Access Compliance Report

Public Rights-of-Way

(Curb Ramps)

Intersection ID: N/A	Main Street: E TRADE ST	Cross Street: S BREVARD ST	Location:	N
ADA ID: 25F37663BDAF	Ramp Type: Perp	Initial Pass/Fail: Fail	Overall Compliance: No	Severity Score: 37.5
Codes/Mitigation Info/Possible Solution		Field Measurements/Component Compliance

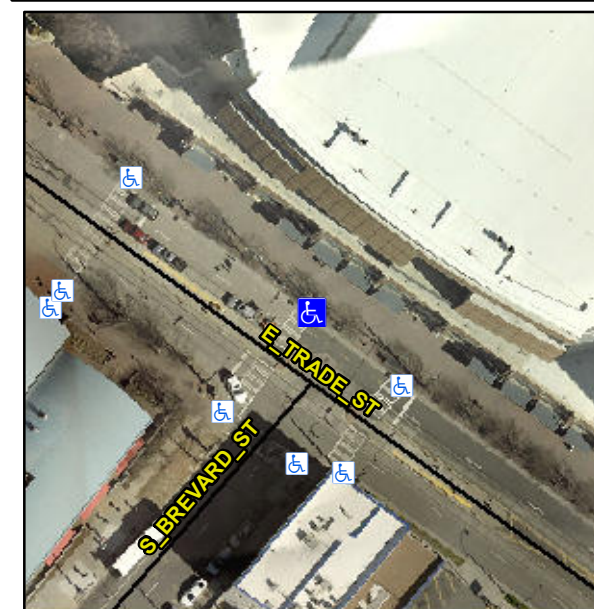
Not Found, R304.2.2, R304.5.3

Compliance	Description	Data	Compliance	Description	Data
N/A	Ramp Length (in)	90.0	No	Ramp Slope (%)	8.7
Yes	Ramp Width (in)	48.0	No	Ramp XSlope (%)	7.3
N/A	Flare Type LT	N/A	N/A	Flare Type RT	N/A
N/A	Flare Slope LT (%)	N/A	N/A	Flare Slope RT (%)	N/A
N/A	Flare Traversable LT?	No	N/A	Flare Traversable RT?	No
N/A	Landing Length (in)	N/A	N/A	DWS Provided?	N/A
N/A	Landing Width (in)	N/A	N/A	DWS Contrast?	N/A
N/A	Landing Slope (%)	N/A	N/A	DWS Length (in)	N/A
N/A	Landing X Slope (%)	N/A	N/A	DWS Full Width?	N/A
N/A	Landing Curb? (Y/N)	N/A	N/A	DWS Offset (in)	N/A
N/A	Shared Landing?	N/A			
N/A	Gutter Ponding?	N/A	N/A	Gutter Slope (%)	N/A
N/A	Gutter Lip Ht (in)	N/A	N/A	Gutter X Slope (%)	N/A
N/A	Painted X Walk1?	Yes	N/A	Painted X Walk2?	N/A
	X Walk 1 Direction	To SW		X Walk 2 Direction	N/A
N/A	X Walk 1 Width (in)	108.0	N/A	X Walk 2 Width (in)	N/A
	X Walk 1 Slope (%)	2.3		X Walk 2 Slope (%)	N/A
	X Walk 1 X Slope (%)	0.7		X Walk 2 X Slope (%)	N/A

Remove & Replace Entire Ramp.
